Consideration of Comments

Project Name:	2020-02 Modifications to PRC-024 (Generator Ride-through) Draft 2
Comment Period Start Date:	6/18/2024
Comment Period End Date:	7/8/2024
Associated Ballot(s):	2020-02 Modifications to PRC-024 (Generator Ride-through) Implementation Plan AB 2 OT

Tables 1 and 2 and numbered item 8

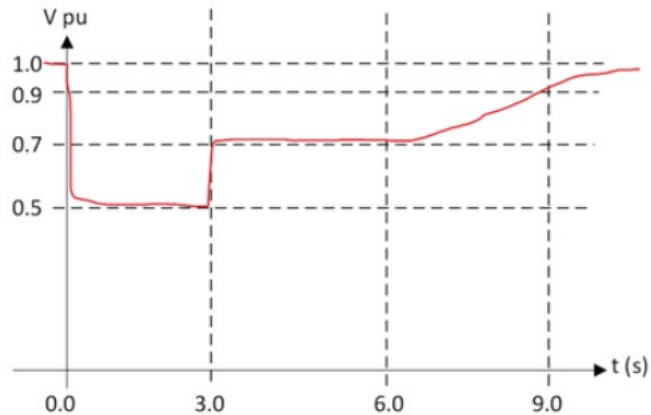
By using voltage bands (e.g., $0.7 \leq V < 0.9$) and time durations this results in a much more stringent requirement than IEEE 2800-2022 Clause 7. The SDT should consider removing the voltage bands to align with IEEE 2800-2022 Clause 7. Take this example where the red is a fictitious voltage plot:
